CITY PLAN COMMISSION STAFF REPORT

Wild Flower

Hearing Date July 7, 2020

Item	Case	Request
#8.1	CPC-2020-00053	Rezoning
#8.2	CPC-2020-00054	Preliminary Plat

Preliminary Plat
Wild Flower, Lots 1-18 & Tract A
Section 25, Township 52 North, Range 32 West
Kansa City, Clay County, Missouri

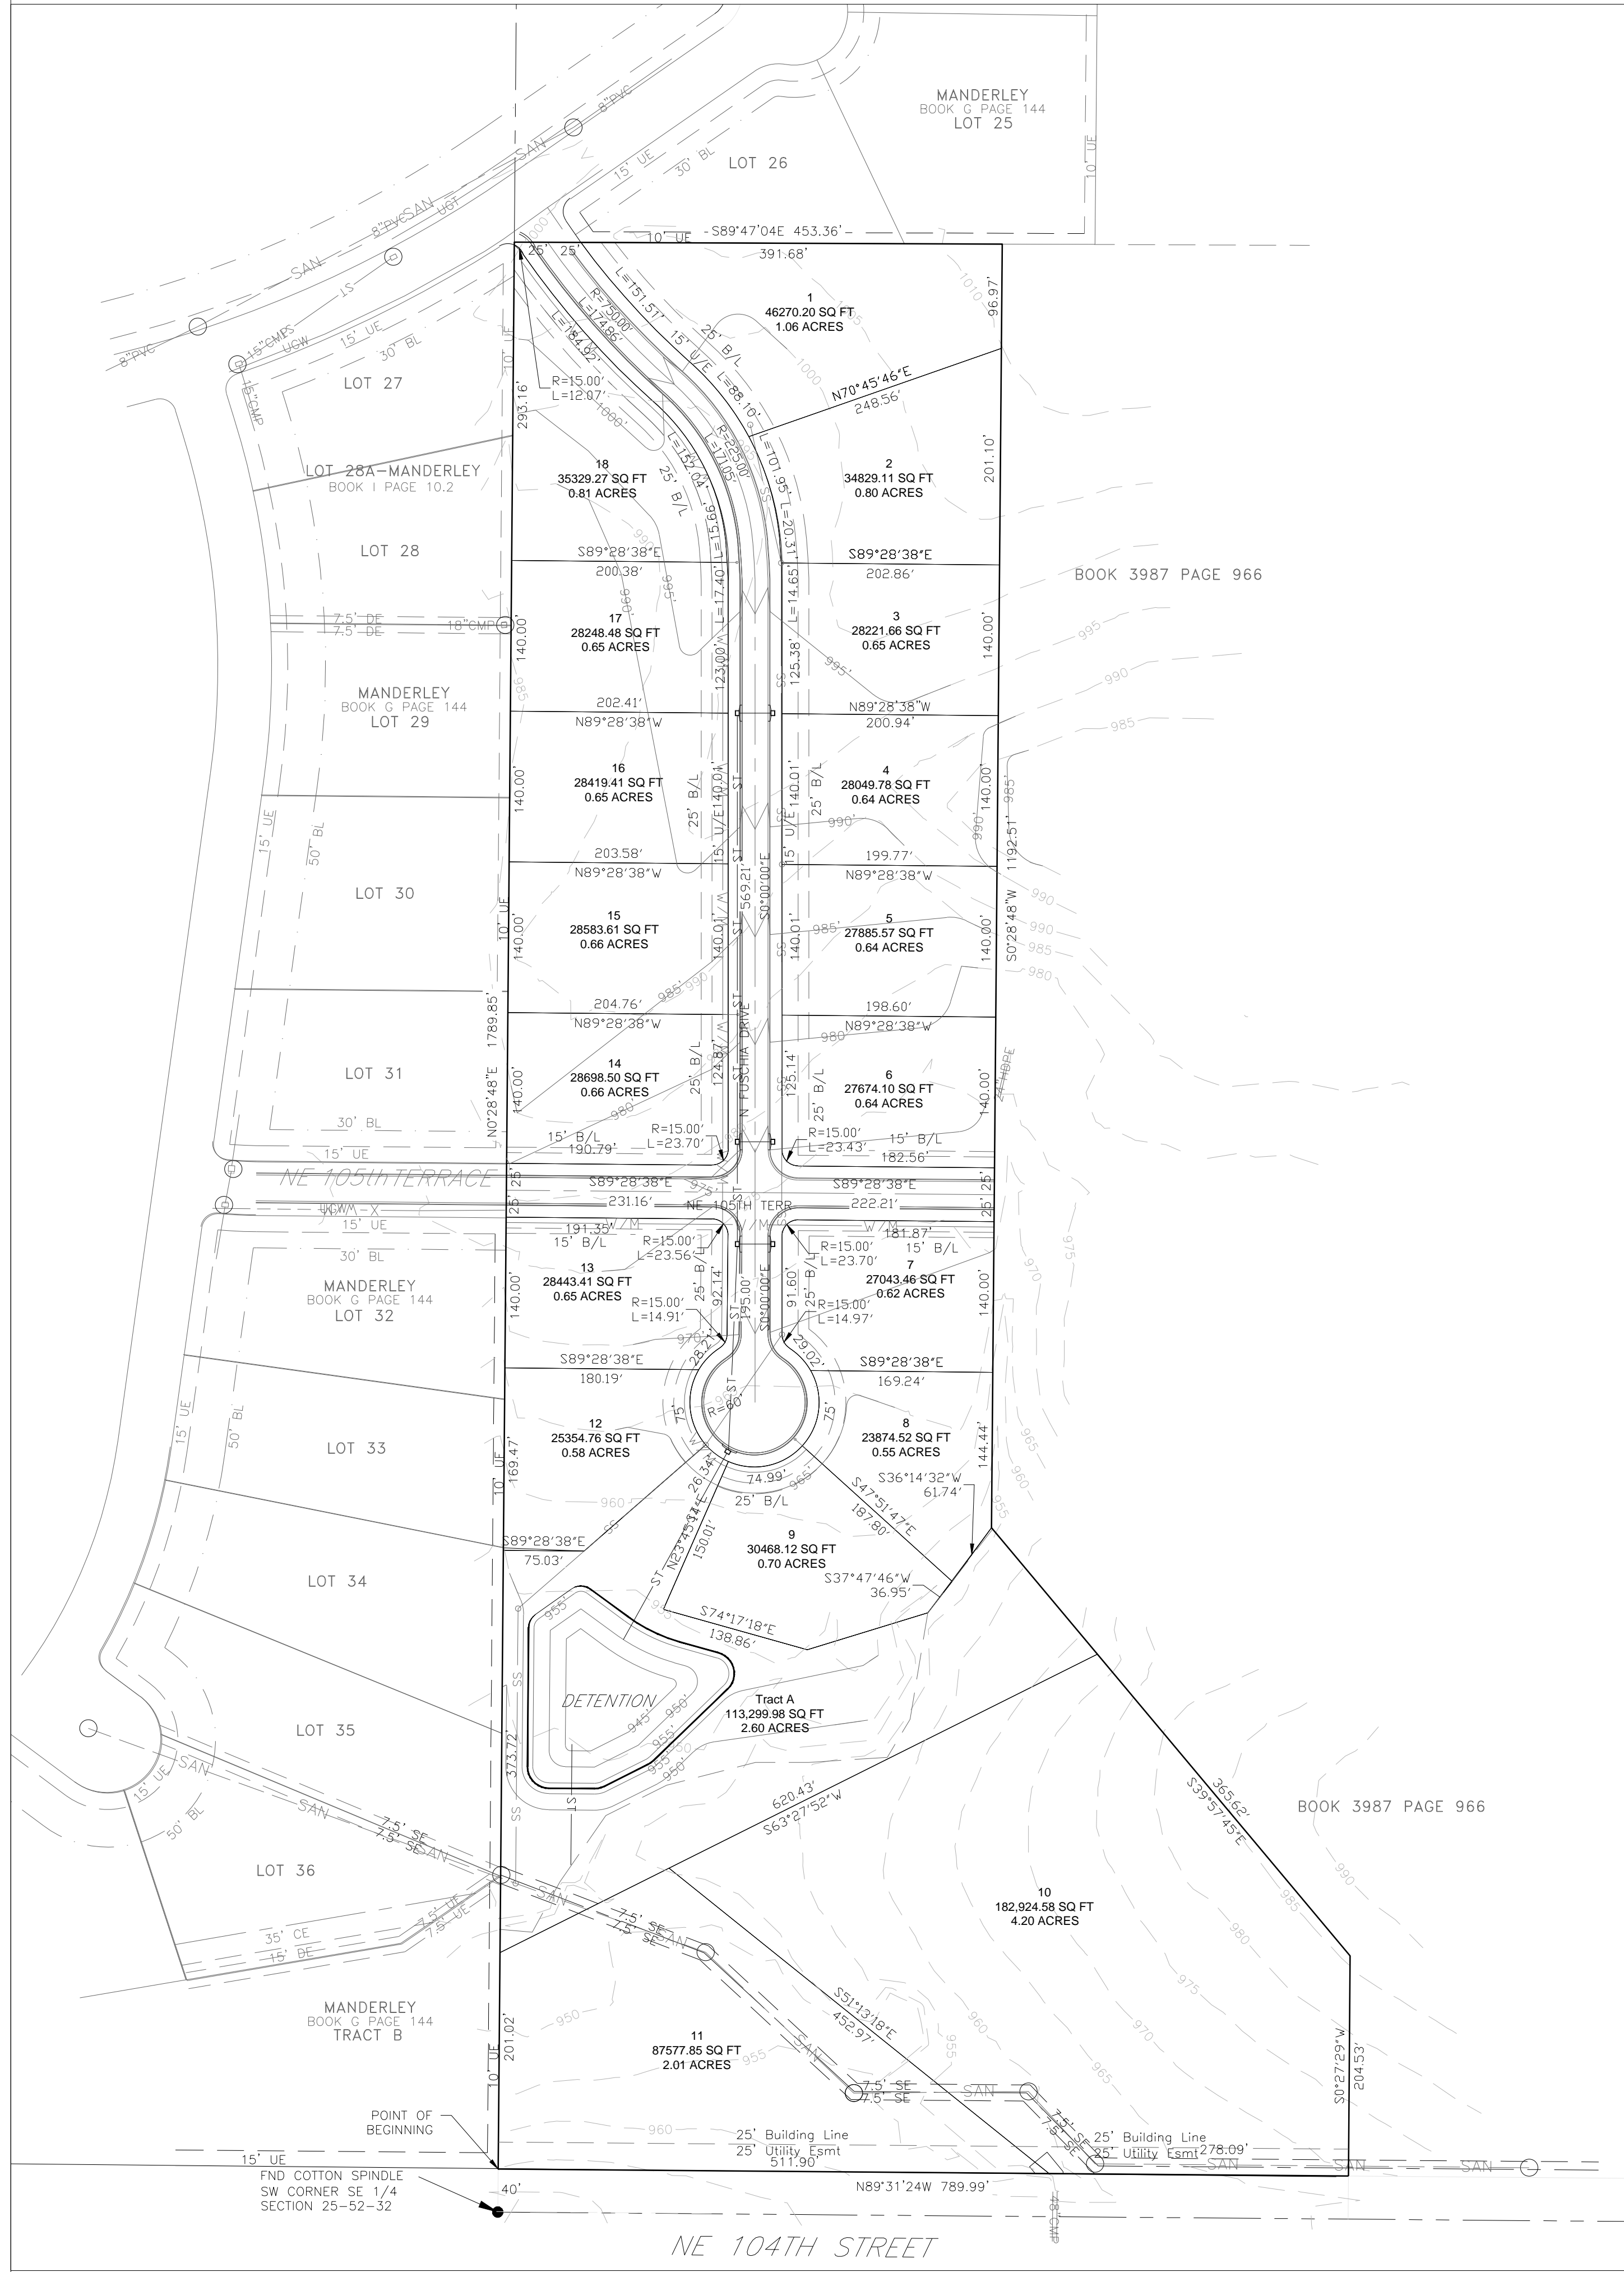
1. That the developer shall submit plans, revised as noted below, to the Development Management Division via Compass PRIOR to City Council consideration:
 - a. Call out any request for waiver, deviation and modification to the subdivision regulations on the face of the plat.
 - b. Call out any request for deferment or desire to post bonds in lieu of constructions of public improvements on the face of the plat.
 - c. Clearly depict all POS tracts and amenities to be dedicated in lieu of parkland.
 - d. Provide a trail at the termination of the cul-de-sac through the detention tract to connect to the existing trail system to the west and eventually to NE 104th Street.
 - e. Show 50 feet front and rear yard setbacks and 30 feet side on corner setback.

- f. Show and label that the water line will be installed in a dedicated water easement.
- g. Extend public water mains as required by the water services department.
